SECTION 00 91 15

ADDENDUM NUMBER 6

- 1.01 DATE: APRIL 6, 2021**
- 1.02 PROJECT: WELCOME CENTER**
- 1.03 PROJECT NUMBER: DCM NO. 2020604**
- 1.04 OWNER: ALABAMA A&M UNIVERSITY**
- 1.05 ARCHITECT: NOLA | VAN PEURSEM ARCHITECTS, PC**

SHEET NUMBER
A-5.3
OF

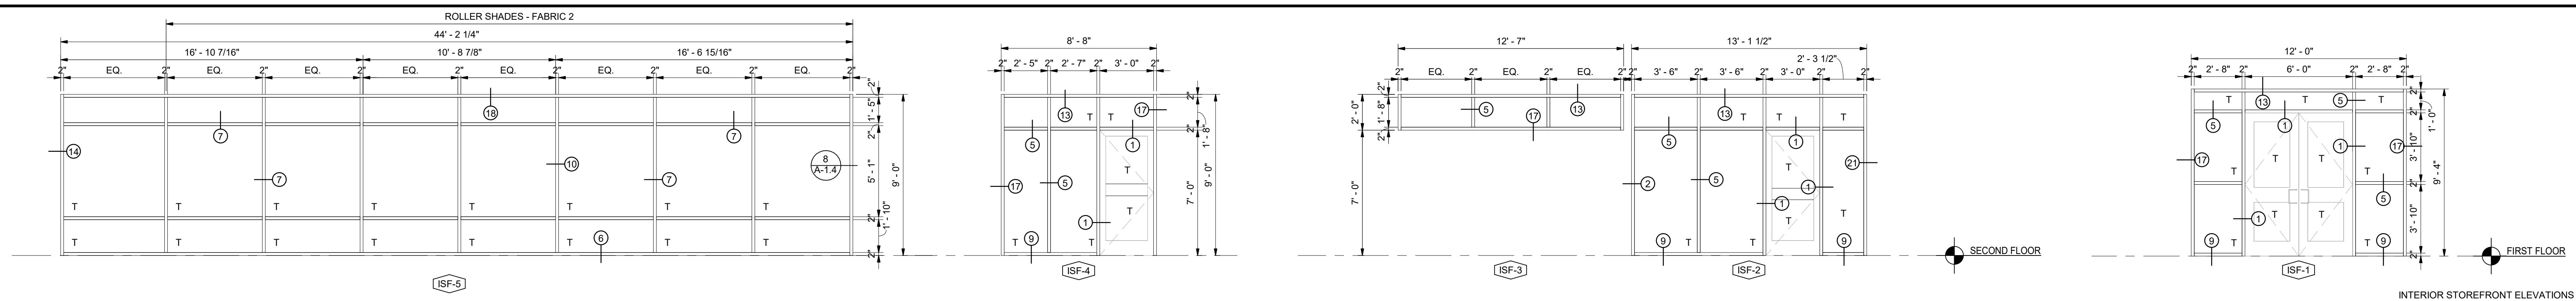
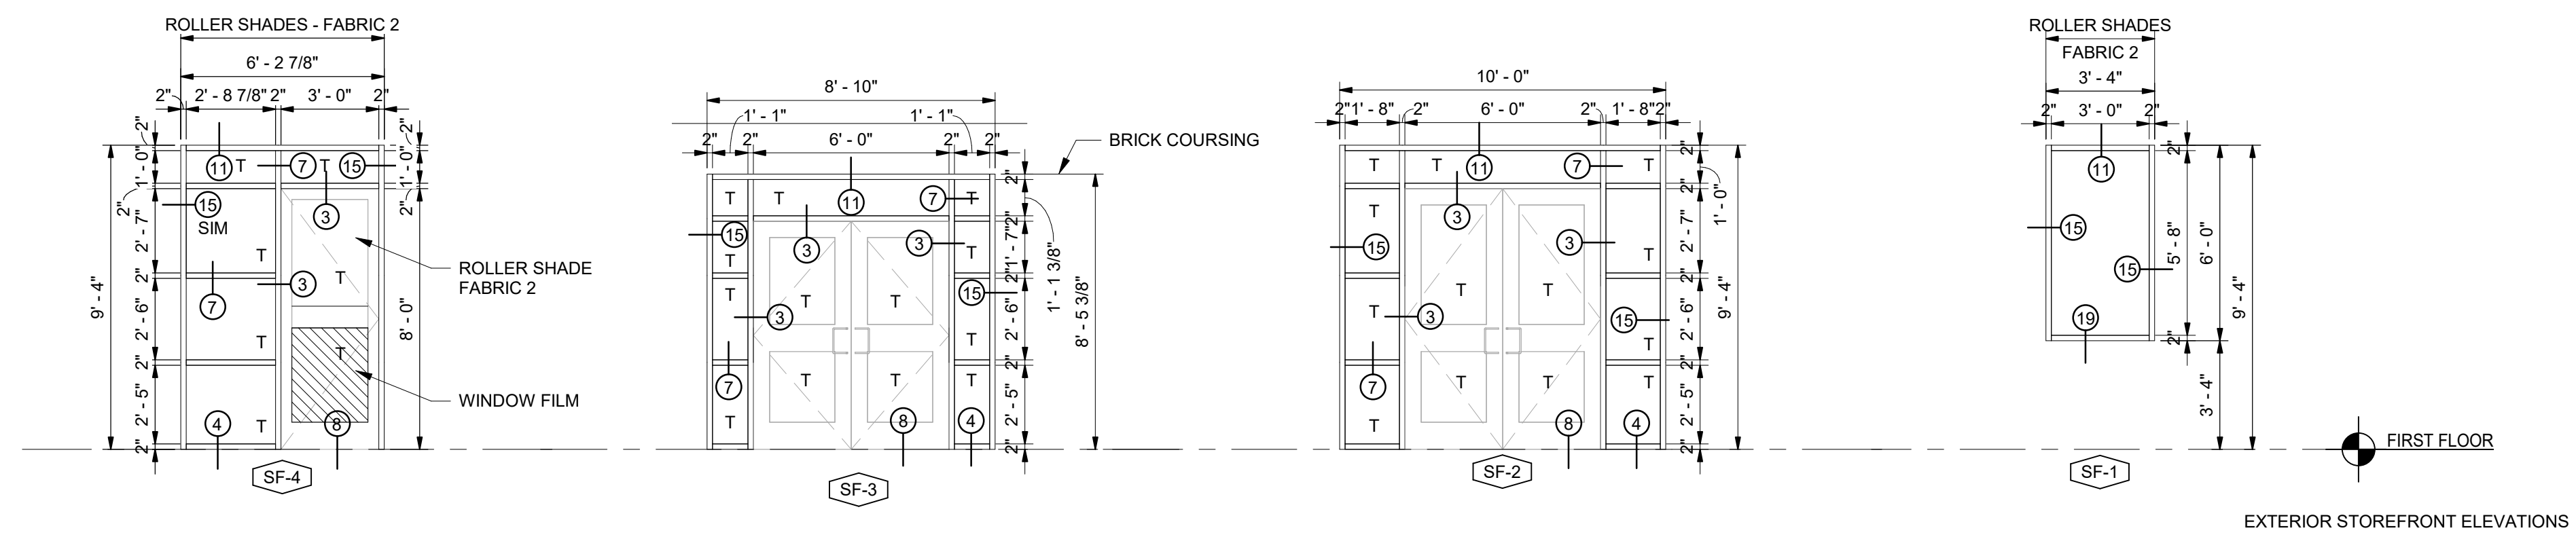
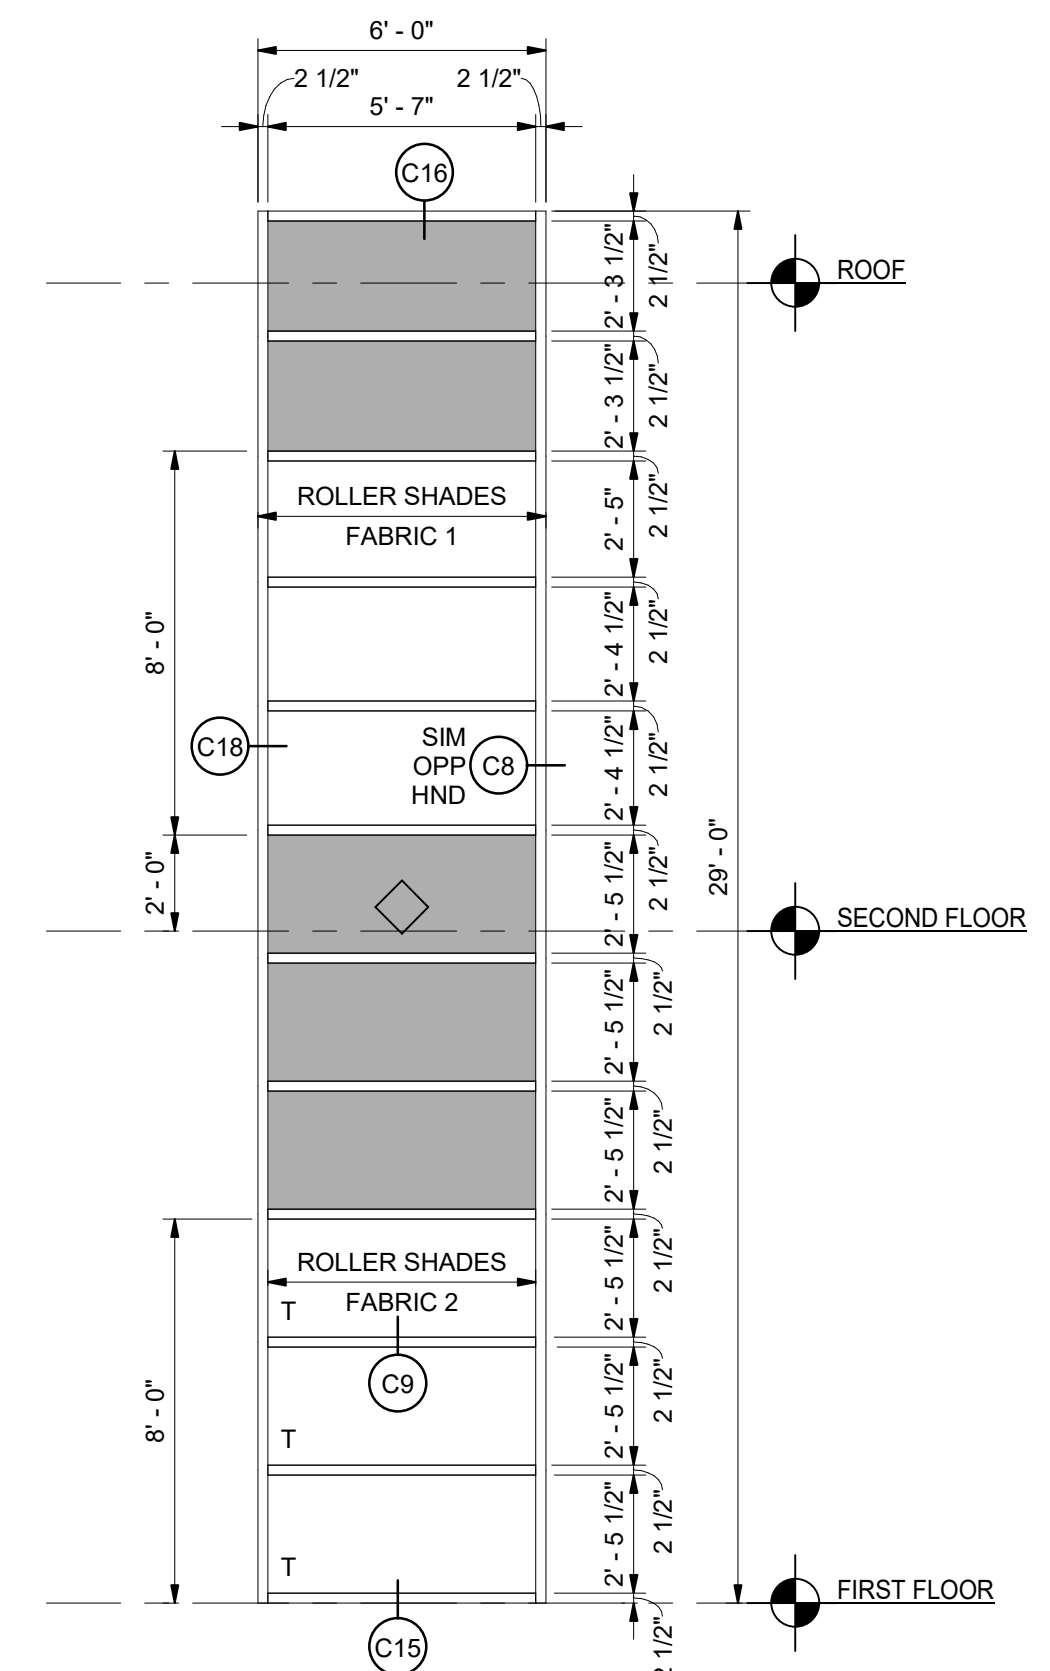
4.10 SHEET A-5.3 – CURTAINWALL ELEVATIONS:

- A. Replace this sheet in its entirety. Revisions include the following:
1. Adjusted dimensions on curtain wall elevations.
